Item Name: Strut Bracket

APICAL INDUSTRIES, INC.	ENGINEERING CHANGE NOTICE NO. 03697				SHEET 1 OF 1	
	DWG NO. 646.3800	REV: N/C	PREPARED BY B. PETERS	DATE: 11/14/12	EFFECT ON DWG <input type="checkbox"/> INC. <input checked="" type="checkbox"/> UNINC.	
	DWG TITLE: BRACKETS					
	APPROVED BY: ENGR <i>[Signature]</i>	MFG <i>David Baker</i>	QC <i>[Signature]</i>	EFF: NEXT ORDER		
TRANSACTION CODES (TC): A-ADD C-CREATE R-REVISE D-DELETE	REASON: ADDED ALTERNATE MATERIAL.				ECR: D-12-006

SHEET 1, ZONE A2 IS:

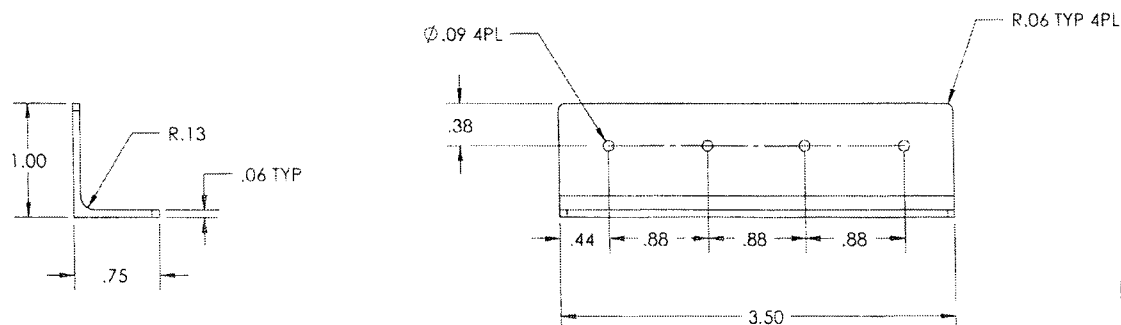
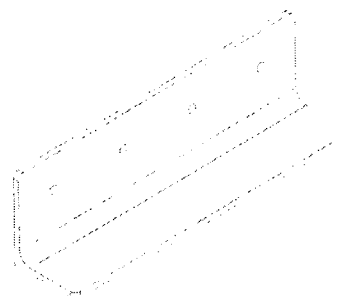
⚠ PRIMARY MATERIAL: 7075-T651 ALUMINUM PER AMS-QQ-A-250/12.
ALTERNATE MATERIAL: 7075-T6511 ALUMINUM PER AMS-QQ-A-200/11.
